Transmitted by the expert from OICA

PROPOSAL FOR DRAFT AMENDMENTS TO REGULATION No. 107

Note: The text reproduced below was prepared by the experts from OICA in order to correct and to standardise the text of Regulation No. 107 including its 02 series of amendments up to and including supplement 2. The draft supplement 3 has also been considered and the relevant paragraphs require no further amendments.

ACCESS TO EMERGENCY DOORS

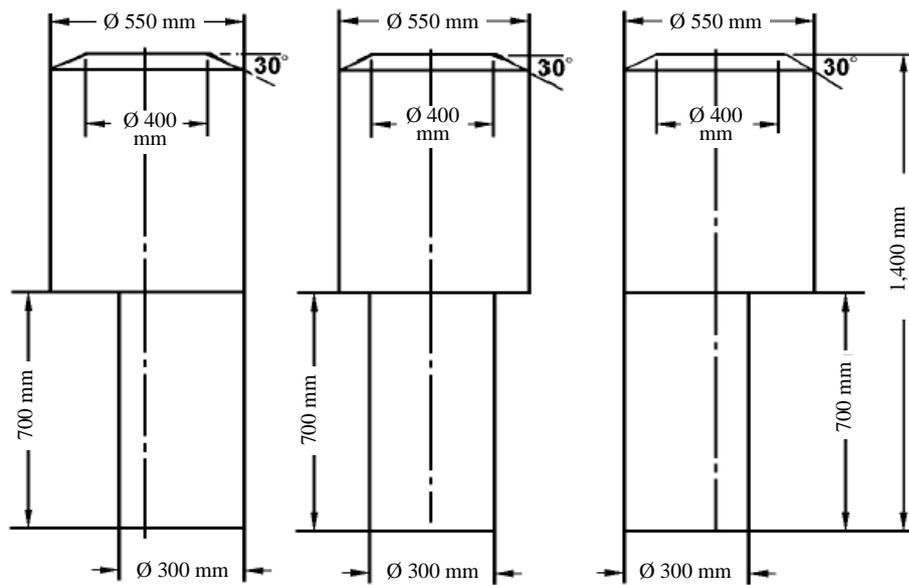
Figure 5, amend to read:

The base of the first cylinder shall be within the projection of the second cylinder. "

To add footnote which is moved from Annex 3, paragraph 7.7.2.2.

GANGWAYS

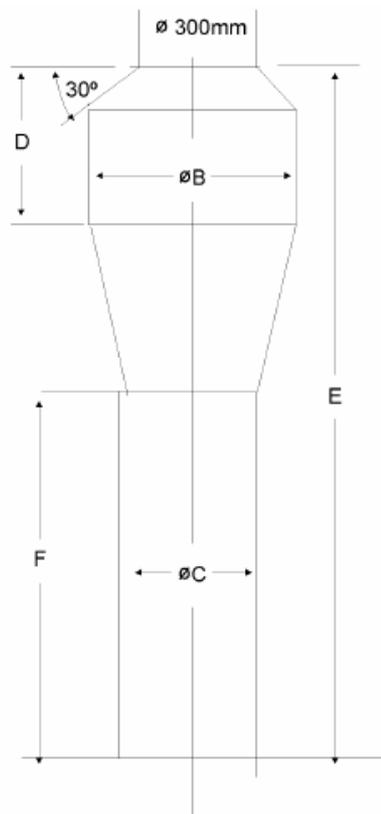
Figure 6, amend to read:

Single deck						
Class		B (mm)	C (mm)	D (mm)	E (mm)	F (mm)
A		550	350	500 (<u>4</u> /)	1,900 (<u>4</u> /)	900
B		450	300	300	1,500	900
I		550	450 (<u>3</u> /)	500 (<u>4</u> /)	1,900 (<u>4</u> /)	900
II		550	350	500 (<u>4</u> /)	1,900 (<u>4</u> /)	900
III		450	300 (<u>2</u> /)	500 (<u>4</u> /)	1,900 (<u>4</u> /)	900
Double deck						
I	LD	550	450 (<u>3</u> /)	500	1,800 (<u>1</u> /)	1,020 (<u>1</u> /)
	UD	550	450(<u>3</u> /)	500	1,680	900
II	LD	550	350	500	1,800 (<u>1</u> /)	1,020 (<u>1</u> /)
	UD	550	350	500	1,680	900
III	LD	450	300 (<u>2</u> /)	500	1,800 (<u>1</u> /)	1,020 (<u>1</u> /)
	UD	450	300 (<u>2</u> /)	500	1,680 1,800	900

To correct an error to dimension "E" for Class III double deck vehicles, which was introduced in the 02 Series of amendments.

STEPS FOR PASSENGERS

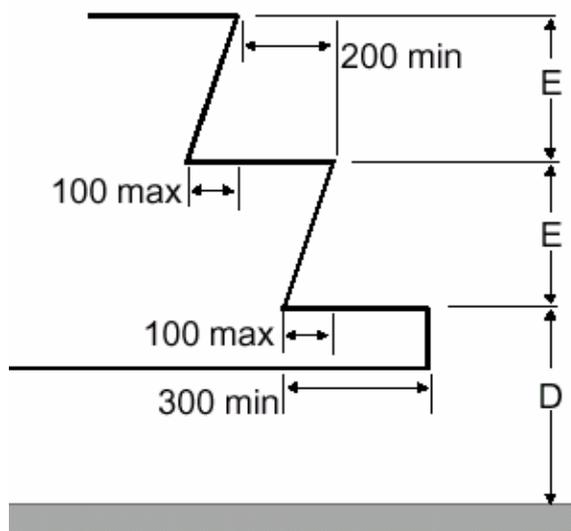
Figure 8, amend to read:

(*) 230 mm for vehicles **of Class A or B** ~~having a capacity not exceeding 22 passengers.~~

(4) 250 mm in gangways for vehicles **of Class A or B** ~~having a capacity not exceeding 22 passengers.~~

Standardisation on Class of vehicles and not on the number of passengers
